# HOSHIZAKI AMERICA, INC.

## SERVICE BULLETIN

**SB95-0002**

**SUBJECT: NEW FLUSH MOUNT REMOTE SYSTEMS**

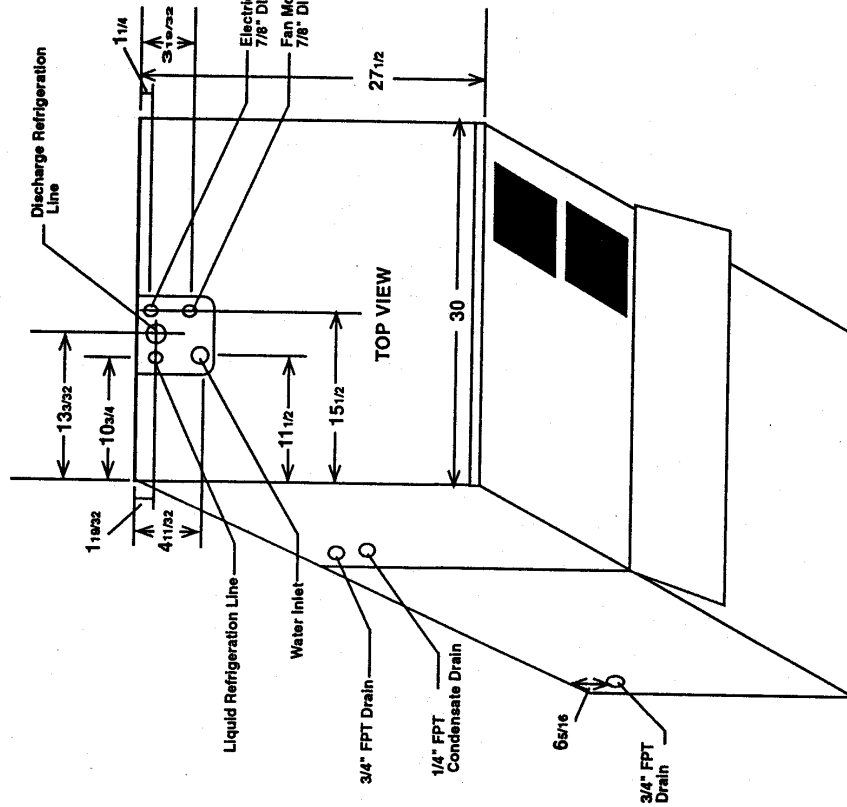
The remote line connections, water connection and electrical supply openings are relocated to the top of the unit. The drain connections are relocated to the left side of the unit. This allows the unit to be installed flush against the wall to conserve floor space.

The top panel must be removed to access the electrical junction boxes when making the initial electrical connections.

The condensate drain has been changed from the 3/8" ID flex tubing to a 1/4" FPT connection which should be piped in the normal manner.
